Report to	Norwich highways agency committee 21 January 2016	Item
Joint report of	Executive Head of Service, Regeneration and Development (county) and head of city development services (city)	6
Subject	Transport for Norwich - Catton Grove Road - Woodcock Road roundabout and 20mph speed limit.

To consider the responses to Catton Grove Road - Woodcock Road roundabout improvement and 20mph area statutory consultation and approve the proposals for implementation.

NORWICH City Council City Hall, Norwich, NR2 1RH Telephone 0344 300 3030		
Drawing Title CCAG2 Project 9 Catton Grove Road Woodcock Road Roundabout CCAG/PH2/09/CON/1		
Drawn: BB	Scale: 1:500	Date: Oct 2010
<small>© Crown Copyright and Database right 2010. Ordnance Survey 100019247.</small>

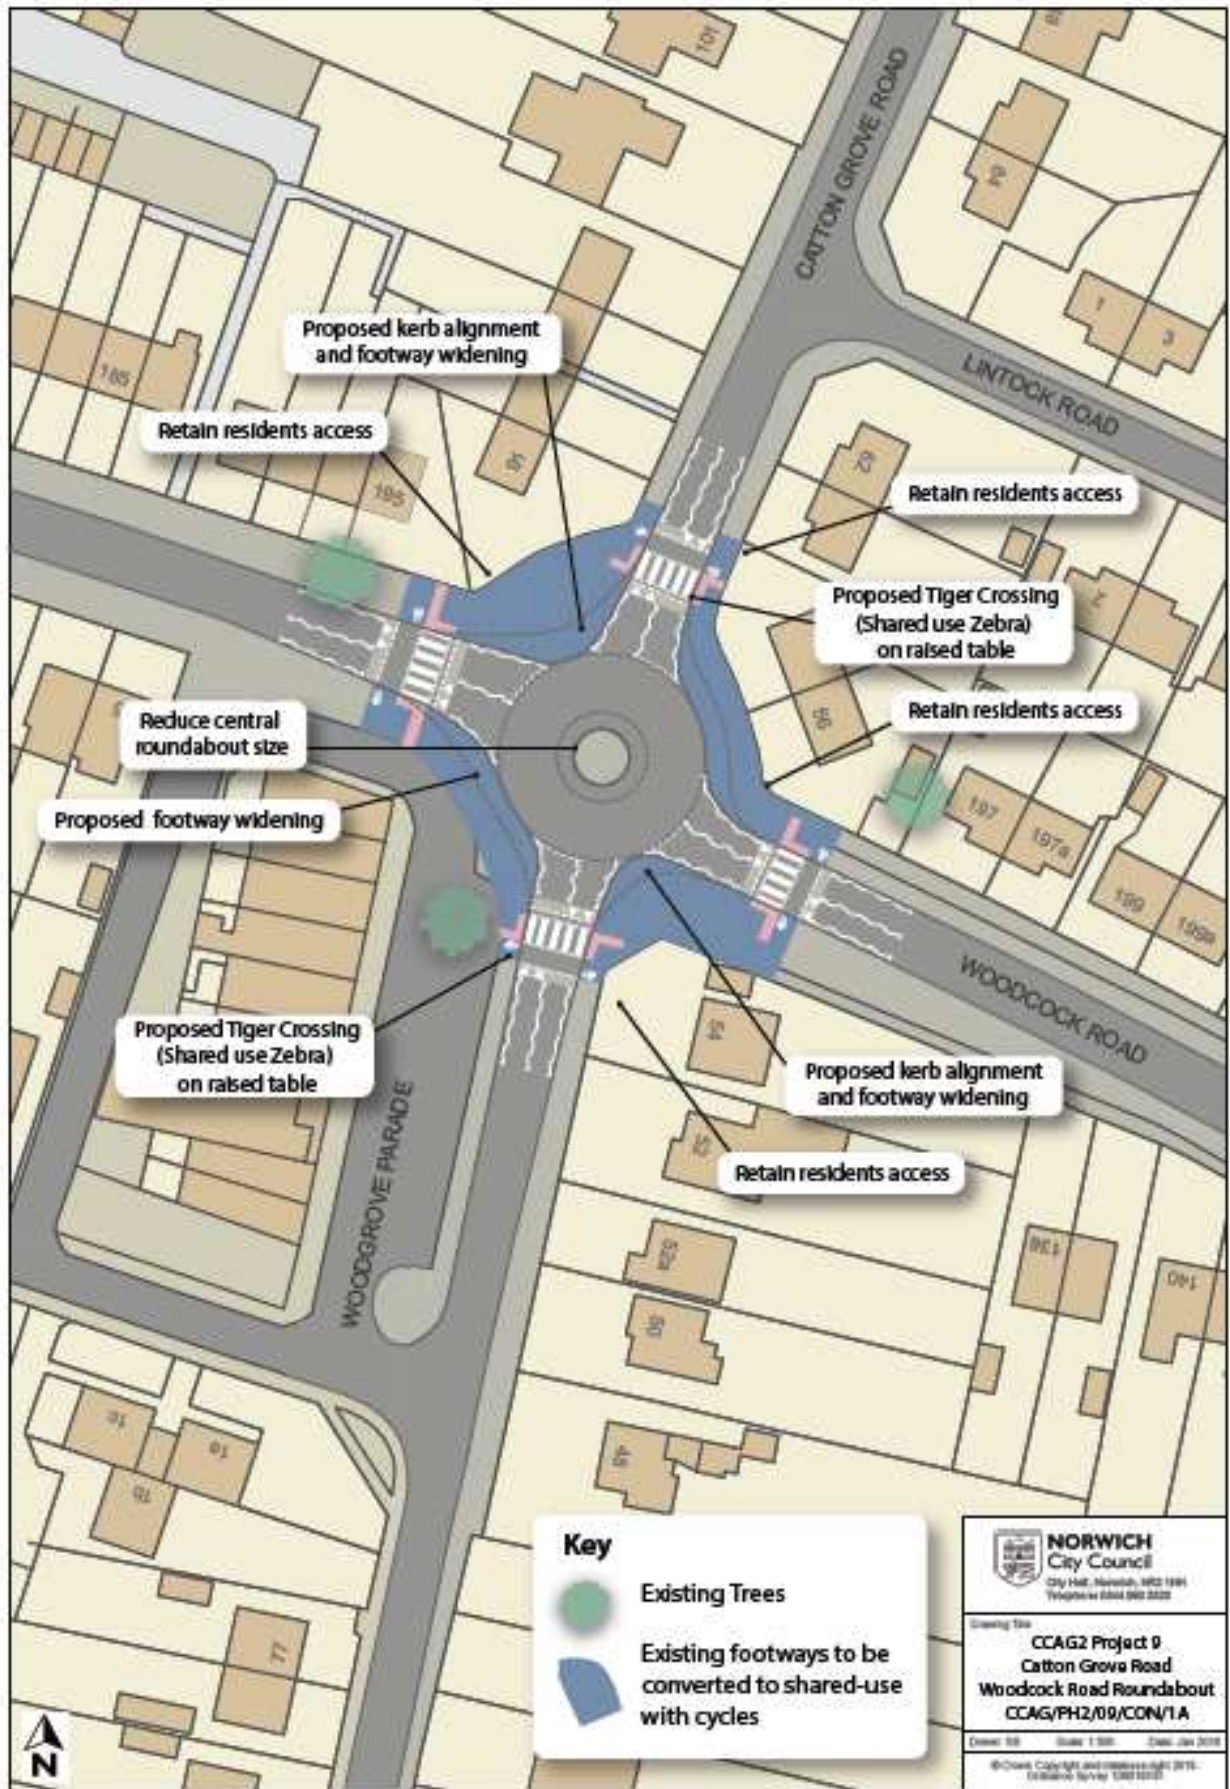
21. Consultation Plan CCAG/PH/09/CON/1 showing the roundabout proposals consulted is attached as Appendix 2. It is to be noted here that following an independent Road Safety Audit of these proposals, the layout for the pedestrians and cyclists across each of the four shared-use cyclist/pedestrian crossings has been switched from what is shown on the plan in Appendix 2. Cyclists will now be guided on to the outer perimeter of the roundabout, with the pedestrians being on the inner perimeter of the crossing. The updated proposal is shown on Plan CCAG/PH/09/CON/1A included in Appendix 4. This will enable cyclists to access and egress the crossing points as they make the transition from on-carriageway to off-carriageway.

Consultation Response comments	Number of respondents	Officers response to Respondent.
Disagree (roundabout proposals)	<ul style="list-style-type: none"> • There is only a low pedestrian throughput on these four roads, even during school time there is very rarely more than a few people waiting to cross the road at any one time. Adding in four zebra crossings to help people cross seems overly excessive. Especially as there is already a central crossing area on Woodcock Road west. Why not add another central crossing area on Catton Grove Road south as this is where the majority of the school children go after visiting the shops. • The widening of the paths is likely to make the road more dangerous to pedestrians as it will be more difficult for buses/lorries to pass one another, leading them to potentially have to mount the kerbs in order to pass. • Adding in these zebra crossings is likely to cause traffic to back up onto the roundabout, again making it more difficult/dangerous for pedestrians/cyclists to cross the road/rejoin. • Encouraging cyclists to use an unsegregated cycle path, while laudable, will mean that cyclists will be leaving and joining traffic at a junction which will be made more congested by the introduction of zebra crossings. This seems much more 	1 objector, with 6 points of comment, from a resident of Catton Grove Road.	<p>The Council officer's response (on 30 November 2015) to the one objector with six comments of disagreement stated that the "comments would be considered and reported to Norwich Highways Agency Committee for Members to make an informed decision".</p> <p>The officer's response concluded by adding "this roundabout has a large proportion of accidents that involve cyclists and pedestrians, mainly caused by traffic speeds. We have also been contacted in the past by residents requesting facilities to safely cross the road at this location, especially to visit the local shops or on way to Sewell Park College. A recent pedestrian survey found a high number of people crossing in this area".</p>

Consultation Response comments	Number of respondents	Officers response to Respondent.
	<p>dangerous than just leaving cyclists on the road or adding an advanced cycle box to the roundabout itself.</p> <ul style="list-style-type: none"> • Three of the zebra crossings (Woodcock Road east, and both Catton Grove Road ones) are extremely close to peoples driveways. This will add another hazard when entering exiting driveways and could potentially cause more accidents. 		
Disagree (roundabout proposals)	<ul style="list-style-type: none"> • The expensive shared paths/cycle tracks which are difficult for cycling. They create a new danger for cycling in that re-joining the carriageway just past the roundabout is a well-documented hazard. It also creates a new conflict between cyclists and pedestrians where it is difficult to negotiate angles. • Making the middle of the roundabout smaller will give the impression that cars can go faster and more directly across it. This would make the situation worse for cyclists. Whereas the current design does encourage the majority of vehicles to take a wider curve around it, it allows buses and large vehicles to negotiate it. • An unpopular and indirect 'cycle provision' avoided by cyclists will lead to more hostility by vehicle drivers believing that cyclists 	1 objector, with 5 points of comment, from Norwich Cycle Campaign.	Officers response covered in paragraph 29 (below)

Consultation Response comments	Number of respondents	Officers response to Respondent.
	<p>should be 'off the road'</p> <ul style="list-style-type: none"> • There is an urgent need for pedestrian crossings for the children going to school, but this should not be the main 'improvement' in a cycle scheme. • Cyclists who do not want to negotiate the roundabout could dismount and use the pedestrian crossings but they should not be encouraged to re-join the carriageway by riding into the road at a dangerous point. 		
Agree	<p>Personally I am delighted by the proposals. This road had become a major cut through (rat run) was very pleased when speed bumps put in not moment to soon even they do not slow a lot of traffic but crossings certainly would. I've watched kids coming out of school downhill crossing opposite Wood Grove Parade for may years, thought there should be a crossing there, at least one but 4 brilliant. Crossings standard or controlled? As for cyclists I'd like them off any path I've been hit 3 times stepping out of my gate! (freewheeling down hill). I fully support the plan.</p>	<p>In agreement, from a resident of Woodcock Road.</p>	<p>The officer's response (on 8 December 2015) to the comment of agreement thanked the resident for their response to the consultation, adding that Members will decide at the January 2016 Norwich Highways Agency Committee whether to implement the scheme.</p>

26. It is to be noted that, due to the high number of accidents involving cyclists together with vehicular speed factors, these proposed shared-use cyclist/pedestrian crossings contribute to the success of the proposals. The proposed solution reduces traffic speeds whilst providing controlled cyclist and pedestrian crossing facilities within the highway parcel.

29. The response to Norwich Cycling Campaign, from the Council officer gave clarity to a couple of questions asked, and the response also stated that
- i) an option for traffic signals at this location had been discounted as unfeasible due to the associated costs of installation and long-term operational and maintenance costs;

- ii) a Dutch-style roundabout with fully segregated cycle lane was not possible in this location due to site constraints of residential accesses, the local shopping precinct and parking areas in the service road, and the highway land available. The proposal however based on Dutch design guides, incorporating shared-use paths to replicate a Dutch-style roundabout concept as near as practicable;

Whilst the central island is being adjusted in diameter, the carriageway width is also being reduced, however, the central island will retain an outer kerbed over-run area with a contrasting paving material not too dissimilar to as existing. The proposed visual appearance of the Woodcock Road Catton Grove Road roundabout will not appear smaller than its present form, however, the over-run proposals will reduce vehicle speed entering and exiting the roundabout to aid the reduction of the current accident history.

- iii) The proposed raised tables with pedestrian/cycle zebra crossings will aid the existing speed reduction measures of the surrounding area.
- iv) The roundabout proposals with the shared-use cyclist and pedestrian crossings will provide a more balanced flow for all users.
